To: Karl Schwing
District Director, San Diego Coast
California Coastal Commission

Re: w20a-4-09-2025 - Permit No. 6-21-0375 (Joseph Steinberg, Encinitas/Solana Beach)

Flooding of beach access to South Cardiff State Beach and front of Steinberg Seawall as observed on November 15, 2024.

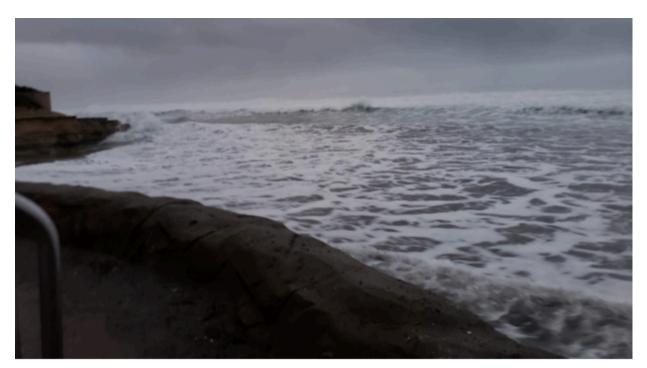
3 The bedrock platform is overtopped under many conditions impeding access.

Even under current sea levels, waves periodically overtop elevated bedrock platform and flood areas in front of the seawall in public easements and below the property line as well as to the property line.
